SOUTH DAKOTA SCIENCE AND TECHNOLOGY AUTHORITY
RFP 2023-14
WWTP RBC Replacement
Amendment #3

ADDENDUM | No. 3

PROJECT	Sanford Underground Research Facility WWTP		
PROPOSAL SUBMISSION DATE	2:00 PM	Mountain Time Zone	May 19, 2023
PROPOSAL SUBMISSION LOCATION	Sanford Underground Research Facility 630 East Summit Street Lead, SD 57754		
ISSUE DATE	May 12, 2023

Issued:	May 11, 2023
Bids Due:	May 19, 2023
Project Name:	Sanford Underground Research Facility WWTP
TSP Project No:	03211470

SHEET No.:
4E-100

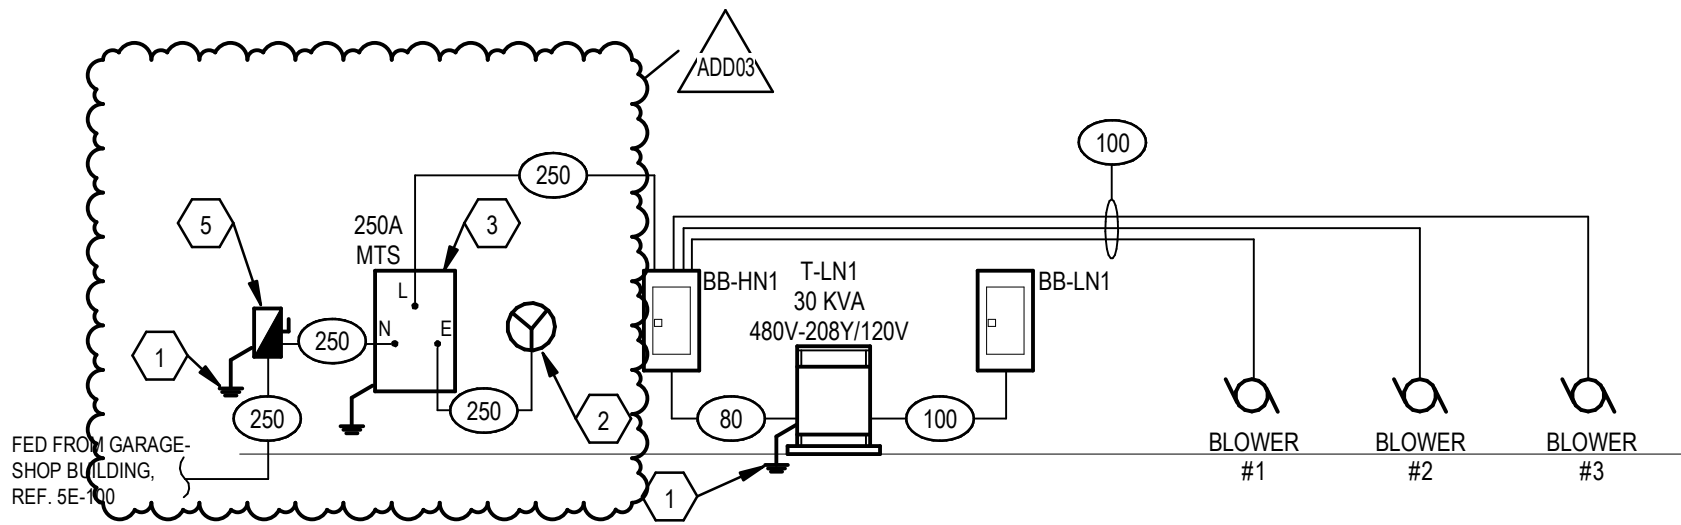
ITEM NO 1: Drawing 4E-100, Blower Building Electrical Plan: Change panelboard BB-HN1 to a 250A panelboard, revise riser diagram and associated keynotes to indicate 250A in lieu of 400A.

- 1. GROUND PER NEC AND DETAIL 1/E-501.
- 2. PROVIDE PIN AND SLEEVE RECEPTACLE FOR PORTABLE GENERATOR CONNECTION: 250A, 480V, 3-PHASE, 3-WIRE CONNECTION. PORTABLE GENERATOR BY OWNER. CONFIRM RECEPTACLE CONFIGURATION WITH OWNER.
- 3. PROVIDE 250A MANUAL TRANSFER SWITCH IN NEMA 3R ENCLOSURE.
- 4. PROVIDE COMBINATION MOTOR STARTER/DISCONNECT WITH A 20A, 120V COIL, IN NEMA 1 ENCLOSURE, FOR EF-1. PROVIDE 120V CIRCUIT TO LINE VOLTAGE THERMOSTAT AND MOTORIZED DAMPER (THERMOSTAT AND DAMPER PROVIDED BY MC, REFERENCE SHEET 4M-101 FOR LOCATION). WIRE THERMOSTAT AND DAMPER THROUGH STARTER SO THAT WHEN THERMOSTAT CALLS FOR COOLING, FAN TO TURN ON AND DAMPER TO OPEN.
- 5. PROVIDE A 250A DISCONNECT SWITCH IN NEMA 3R ENCLOSURE, WITH 250A FUSE.

SHEET No. : 4E-101

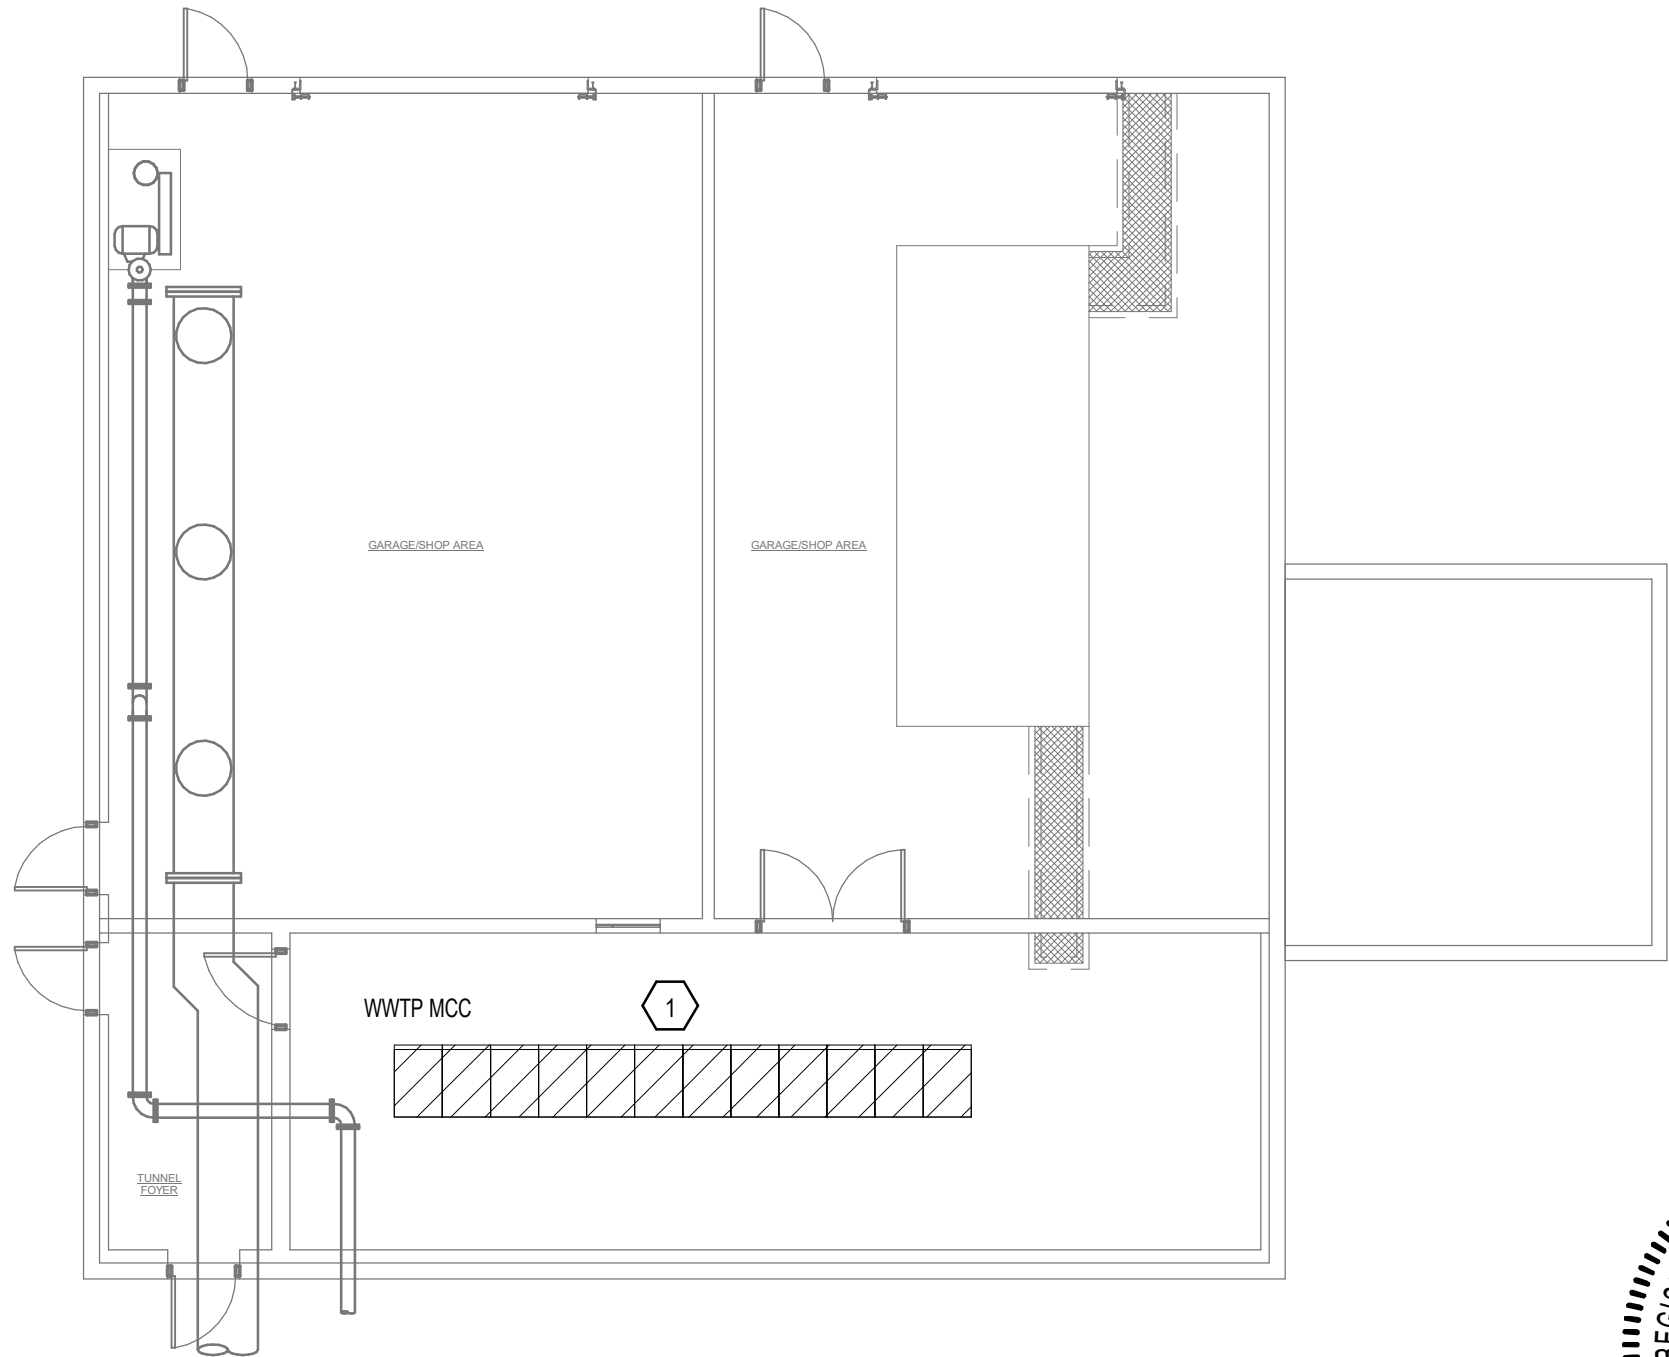
ITEM NO 2: Drawing 4E-101, Blower Building Electrical Schedules: Change panelboard BB-HN1 to a 250A MLO panelboard.

MAIN DEVICE: 250 A MLO

SHEET No. :
5E-100

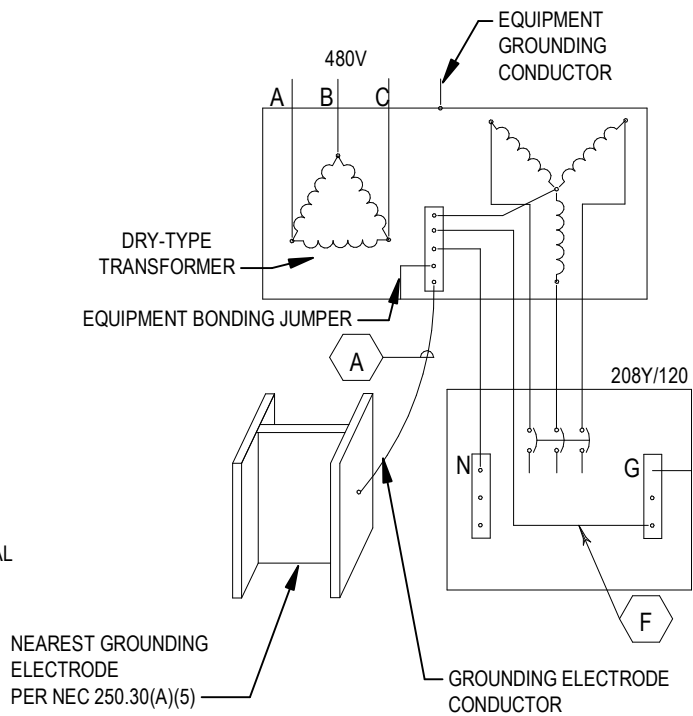
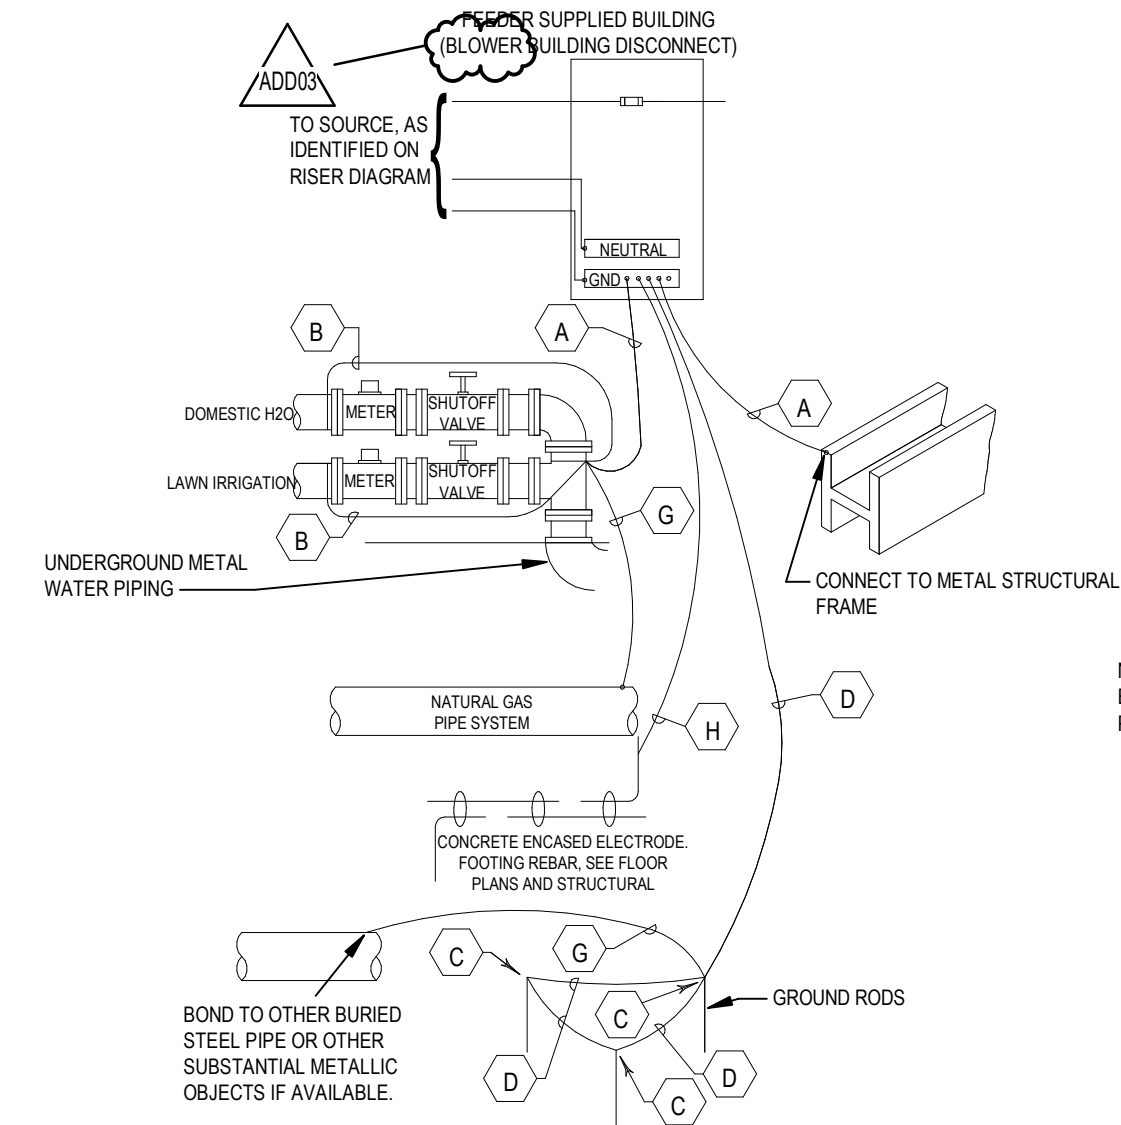
ITEM NO 3: Drawing 5E-100, Garage-Shop Electrical Plan: Revise Keynote 1 as follows: "Modify existing switchgear to feed new 250A panelboard at Blower Building. Existing switchgear is General Electric AKD-8 and 8000 Line Control Center. Provide a new 250A breaker in a spare 18" vertical space. Existing loads currently in the 'off' position may be assumed as spare spaces. Coordinate with Owner to shift existing remaining loads and buckets within the gear to make space for an 18" vertical space for the 250A breaker. Provide blank cover on any remaining space."

1. MODIFY EXISTING SWITCHGEAR TO FEED NEW 250A PANELBOARD AT BLOWER BUILDING. EXISTING SWITCHGEAR IS GENERAL ELECTRIC AKD-8 AND 8000 LINE CONTROL CENTER. PROVIDE A NEW 250A BREAKER IN A SPARE 18" VERTICAL SPACE. EXISTING LOADS CURRENTLY IN THE 'OFF' POSITION MAY BE ASSUMED AS SPARE SPACES. COORDINATE WITH OWNER TO SHIFT EXISTING REMAINING LOADS AND BUCKETS WITHIN THE GEAR TO MAKE SPACE FOR AN 18" VERTICAL SPACE FOR THE 250A BREAKER. PROVIDE BLANK COVER ON ANY REMAINING SPACE.
